Access Compliance Report

Public Rights-of-Way (Curb Ramps)

Intersection ID: 47361	Main Street: PARK_RD	Cross Street: N/A	Location: W
ADA ID: 7183B21F86C3	Ramp Type: Perp	Initial Pass/Fail: Fail	Overall Compliance: No
			Severity Score: 48.75

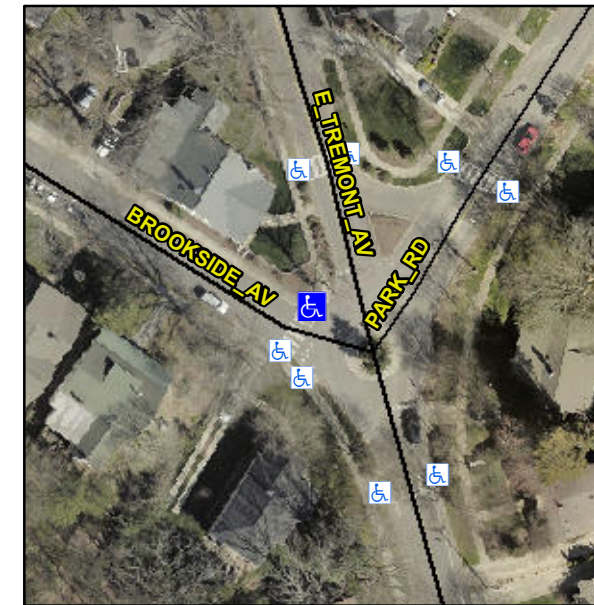
Not Found, R304.5.1, R304.2.2, R304.5.3

Compliance	Description	Data	Compliance	Description	Data
N/A	Ramp Length (in)	49.0	No	Ramp Slope (%)	9.9
No	Ramp Width (in)	30.0	No	Ramp XSlope (%)	3.8
N/A	Flare Type LT	N/A	N/A	Flare Type RT	N/A
N/A	Flare Slope LT (%)	N/A	N/A	Flare Slope RT (%)	N/A
N/A	Flare Traversable LT?	N/A	N/A	Flare Traversable RT?	N/A
N/A	Landing Length (in)	N/A	N/A	DWS Provided?	N/A
N/A	Landing Width (in)	N/A	N/A	DWS Contrast?	N/A
N/A	Landing Slope (%)	N/A	N/A	DWS Length (in)	N/A
N/A	Landing X Slope (%)	N/A	N/A	DWS Full Width?	N/A
N/A	Landing Curb? (Y/N)	N/A	N/A	DWS Offset (in)	N/A
N/A	Shared Landing?	N/A			
N/A	Gutter Ponding?	N/A	N/A	Gutter Slope (%)	N/A
N/A	Gutter Lip Ht (in)	N/A	N/A	Gutter X Slope (%)	N/A
N/A	Painted X Walk1?	Yes	N/A	Painted X Walk2?	N/A
	X Walk 1 Direction	To SW		X Walk 2 Direction	N/A
N/A	X Walk 1 Width (in)	104.0	N/A	X Walk 2 Width (in)	N/A
	X Walk 1 Slope (%)	0.3		X Walk 2 Slope (%)	N/A
	X Walk 1 X Slope (%)	5.4		X Walk 2 X Slope (%)	N/A

Remove & Replace Entire Ramp.
